Product Change Notification

Change Notification #: 834101-00

Change Title: Select Intel® Ethernet Network Adapters,
Swap OEM Gen Bracket Configuration, Update SFP
Cage, OUI and Label

Date of Publication: September 27, 2024

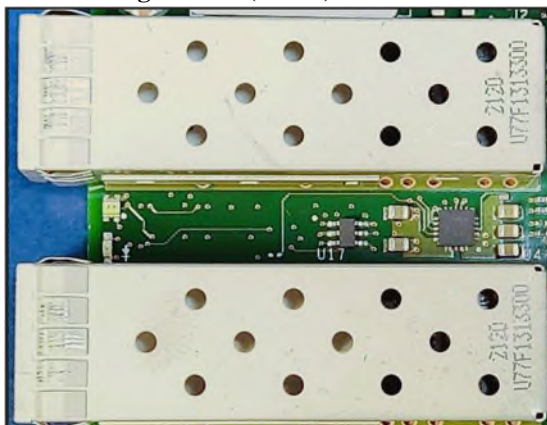
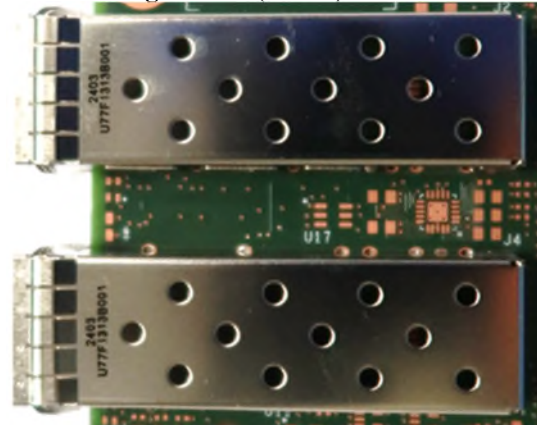
1. The matte tin Small Form-factor Pluggable (SFP) port cages on the below products are being replaced with nickel plated cages to reduce the cages susceptibility to showing scuffs marks or scratches and to improve the visual appearance of the cage. Customers may still receive matte finish cages while existing inventory is being depleted and could receive mixed inventory.

The new cages will appear shinier than the old matte finish cages as shown in the example image below.

Previous Configuration E810XXVDA2G1P5	New Configuration E810XXVDA2G1P5
Full-height bracket installed Low-profile bracket included in the package	Low-profile bracket installed Full-height bracket included in the package

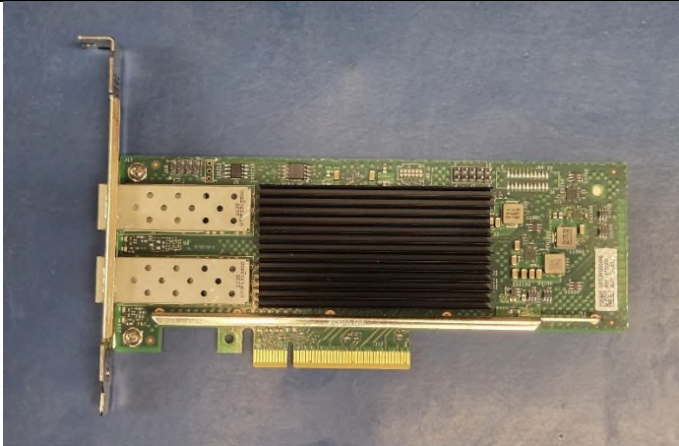
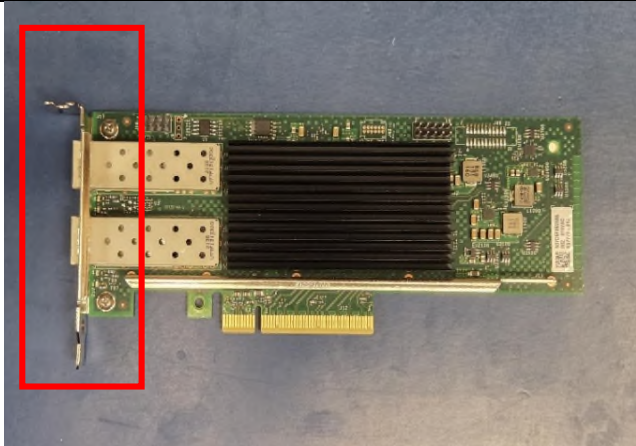
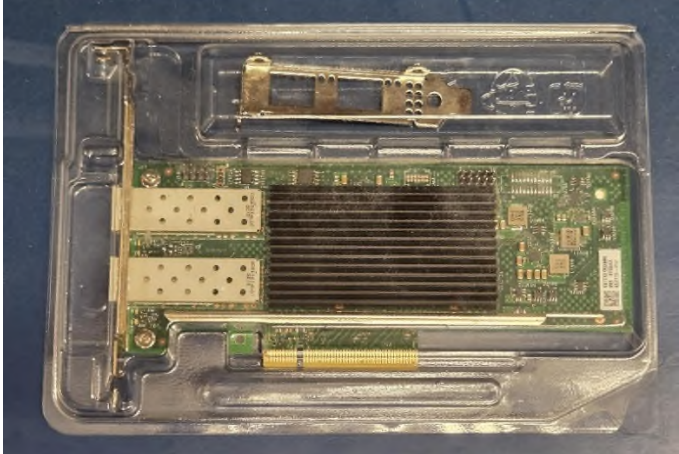
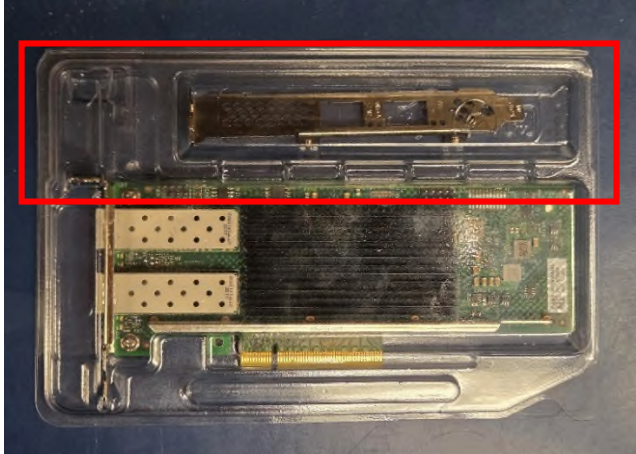
- The bracket shipping configuration will change for Intel® Ethernet Network Adapter E810-XXVDA2 OEM Gen product. These products will now ship with the Low-profile bracket installed on the adapter and the Full-height bracket loose in the clamshell pocket.
